**Re: Technical Revision Request - File No. M-2011-028, Animas Glacier Gravel Pit**

**ANIMAS GLACIER GRAVEL PIT  
DRAINAGE REPORT – Amendment 1**

# ANIMAS GLACIER GRAVEL PIT DRAINAGE BASIN MAP #2 REVISED - 01-22-2014

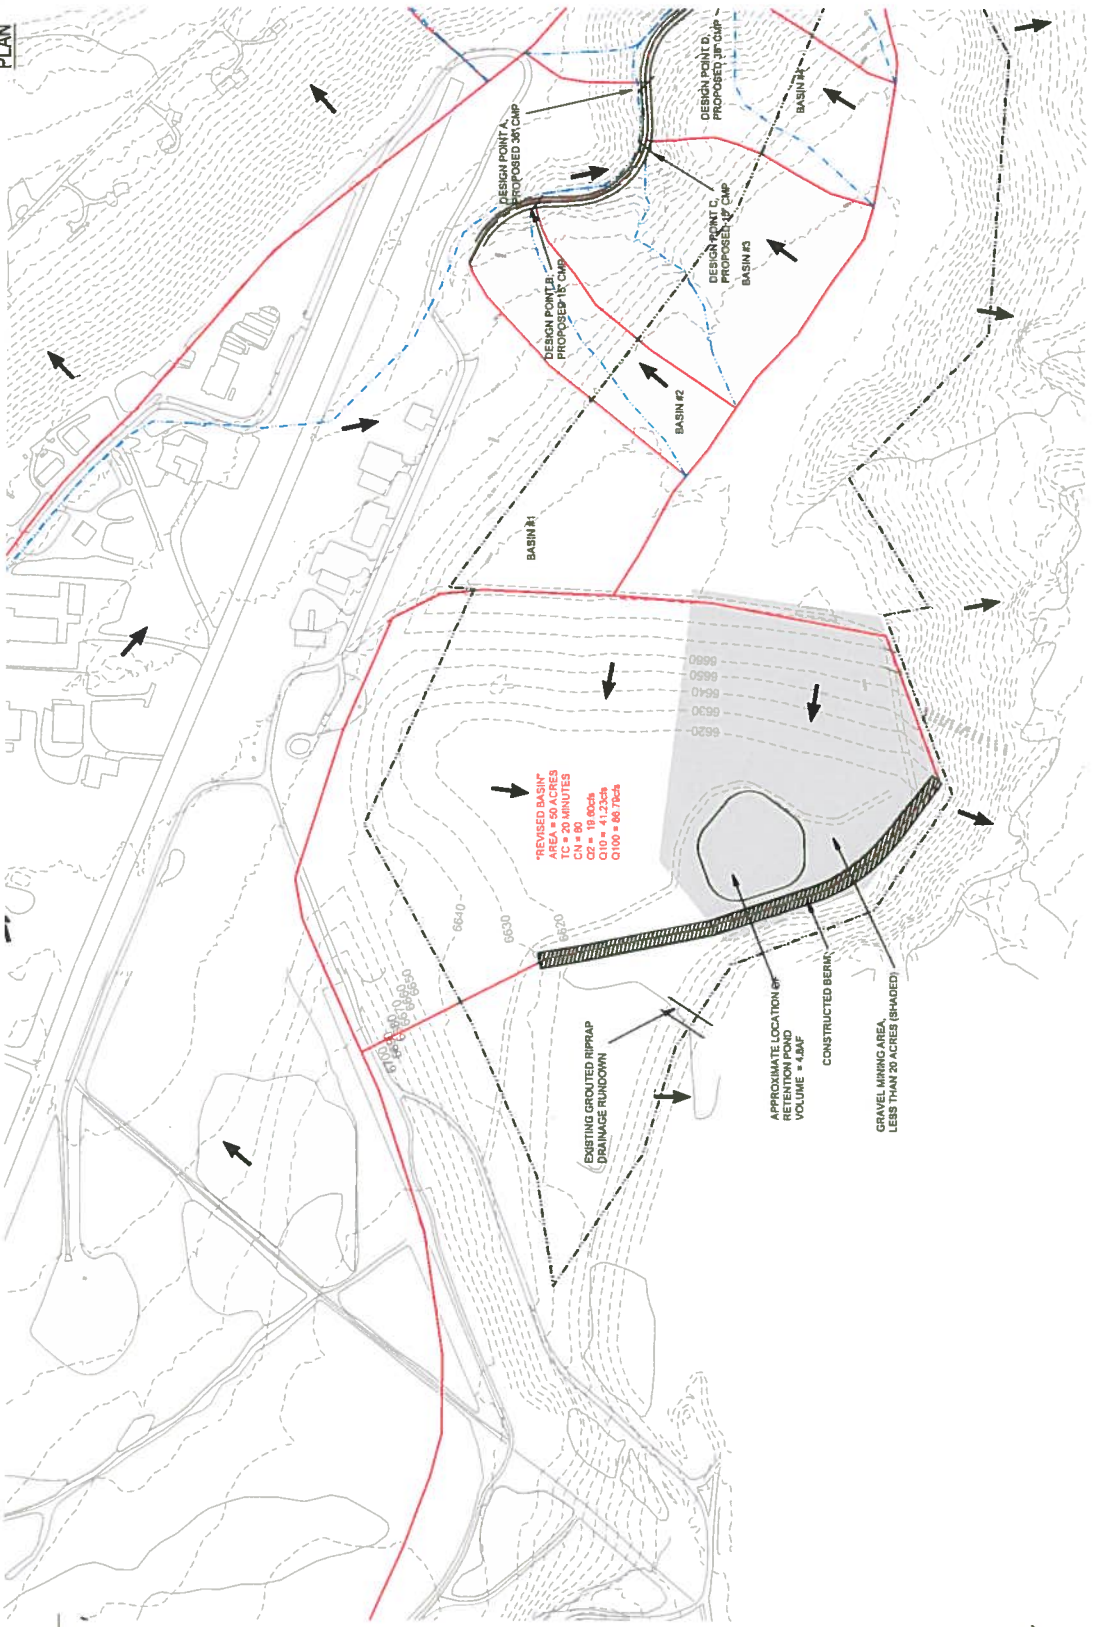
As shown on the attached site plan, the northern extent of the property will remain unaffected. Stormwater drainage across this stretch will reach the existing grouted rundown structure unencumbered by any development or soil disturbance. A perimeter berm was designed to extend along the western rim of the property to the north and east. It is located south of the grouted rundown structure. Based on the existing topography this berm will form a basin, isolating areas to be developed and/or affected from the unaffected area to the north.

As Constructed, the retention pond and the berm will eliminate the originally proposed Grass Lined Swale A, which was intended to route the undisturbed drainage basin around the mined pit area. This change will increase the contributing detention basin to the gravel pit retention pond to approximately 50 acres. The revised basin has been modeled and will have the following characteristics.

The total estimated volume of runoff for a 100 year storm has also been calculated at 6.3 acre-ft, of which 75% would be held within the primary retention pond, while the excess 1.5 acre-ft of water would become nuisance water within the gravel pit. The remaining 220 acre-ft of potential storage volume created by the berm would remain available and allow for an additional 35 consecutive - 100 year storm events before the berm would over top.

See Appendix A for Revised Drainage Basin Map and Hydraflow Calculations.
